Division of Surface Water Response to Comments

Rule: Water Quality Standards Beneficial Use Designation Rules OAC Chapter 3745-1

Ohio EPA held an interested party comment period from January 8, 2016 to February 9, 2016 regarding eight Water Quality Standards beneficial use designation rules. This document summarizes the comments and questions received during the associated comment period.

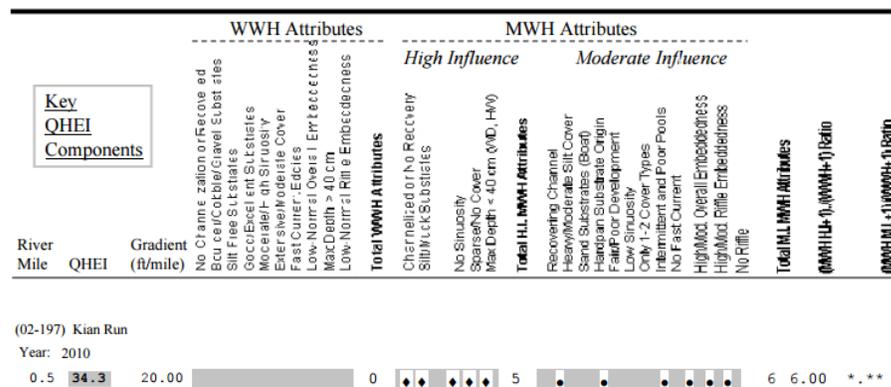
Comment 7: The aquatic life use for Kian Run in the Scioto basin is proposed to be changed from WWH to MWH. The Middle Scioto River Basin Water Quality Report indicates that heavy siltation/sedimentation and poor channel development limit the stream's biological potential. Based on the description, it is unclear whether the stream condition is due to prior channelization or other sources. We request additional information on any stream modification that has occurred within the segment that is the basis of the proposed MWH designation. (U.S. EPA Region 5)

Response 7: As noted in the technical support document, Kian Run exhibits very poor habitat conditions as measured by the QHEI of 34.3, which was the lowest habitat score for any stream in the entire survey area. Direct habitat alterations to this highly modified urban stream on the south side of Columbus include stream bank modifications and channelization. The stream exhibits poor channel development and extensive siltation/sedimentation. As a result, biological community present is well below WWH expectations with an IBI of 24 and an ICI narratively rated as very poor. Biologically, this was the lowest performing stream in the entire survey area. As the QHEI attributes table shows below, Kian Run did not possess a single WWH attribute, and had five MWH attributes of high influence.

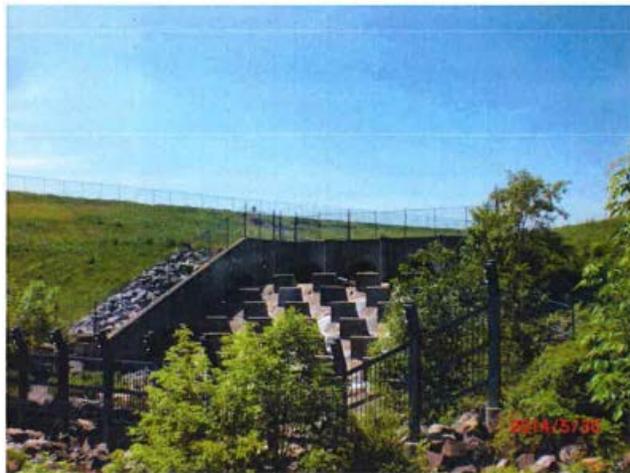
1. Ohio EPA argues that this change is necessary because of the mile-long culvert system installed under the Cleveland-Hopkins International Airport to facilitate runway. This action was permitted by Ohio EPA and the US Army Corps of Engineers. There were better solutions/design alternatives that would have better allowed for fish passage through this stretch of Abram Creek, yet the existing, limiting design was permitted and built. The photo below of the culvert outlet that clearly demonstrates that fish passage was not a design consideration from the start.

Response 9: See response to comment #8, above, concerning Abram Creek. In regard to the comment to consider redesignation of portions of the upper East Branch to EWH, Ohio EPA believes that such an action is not supported by the data at the present time. While the two sites at river mile locations 26.63 and 21.98 fully attain the EWH biocriteria, sites evaluated both upstream and downstream did not. Should future studies show more consistent EWH attainment throughout the upper portion of East Branch, the Agency will consider an EWH designation.
